Application Number: 09/669,784 Filing Date: September 25, 2000

Appellant(s): ISRAELSON, GORDON

EXAMINER'S ANSWER

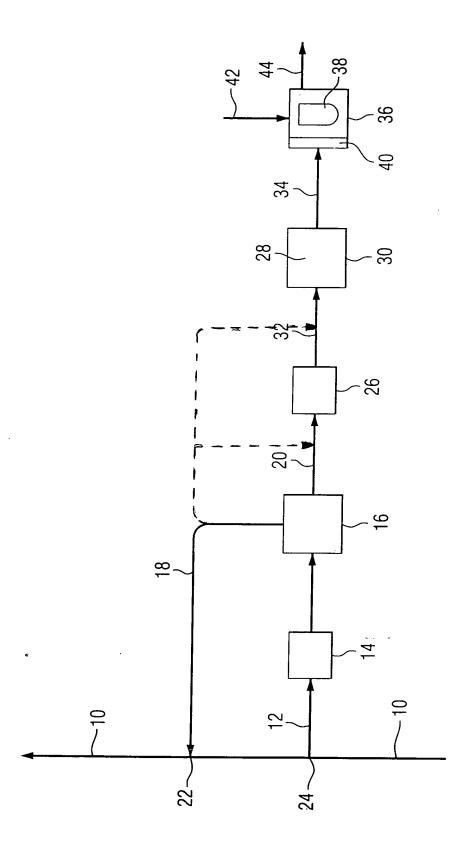
Appellant argues that the recitation of "passing the sulfur concentrated stream back into the main fuel feed stream" in independent claims 1 and 11 is distinct from the teaching of Willis reference.

As pointed in the advisory action dated June 20, 2002, the recitation does not necessarily require the flow of sulfur concentrated stream as indicated in Figure 1 of the instant specification. The limitation encompasses feeding the sulfur-rich stream in alternate locations, as indicated in the marked-up copy of Figure 1. Thus, Willis et al. meet the claim limitation, because Willis et al. disclose passing the sulfur concentrated stream back into the mainstream, even though at a different point than intended by the application.
